PD Signature requirements v300

Info (not part of baseline)

What is the problem?

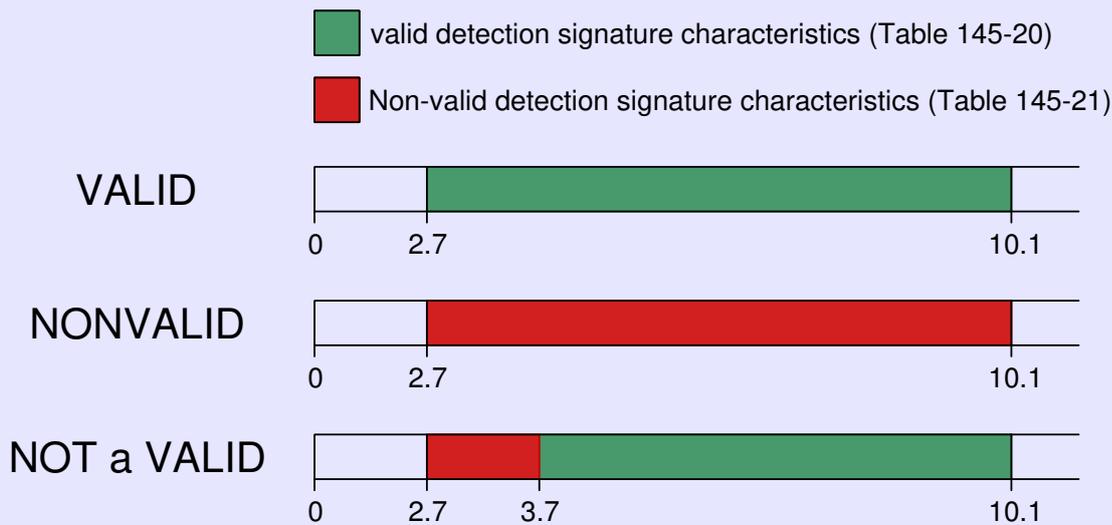
The current text says that a PD shall show an invalid detection signature on a Mode, when a voltage between 10.1 and 57 volt is applied to the other mode. During connection check, the PSE will apply only voltages *less* than 10.1 volt to the other mode. Thus, this requirement does not apply in the voltage range where we need it to apply.

The new requirement (paraphrased) is that: “The PD shall not present a valid detection signature on a Mode when a voltage between 3.7 and 10.1 volt is applied to the other Mode”.

A single-signature PD shall present a valid detection signature, as defined in Table 145–20, on a given Mode when no voltage or current is applied to the other Mode, and shall **not** present an invalid detection signature on that Mode when any voltage between 3.7 ~~+0.1~~ V and 57 V is applied to the other Mode. These requirements apply to both Mode A and Mode B.
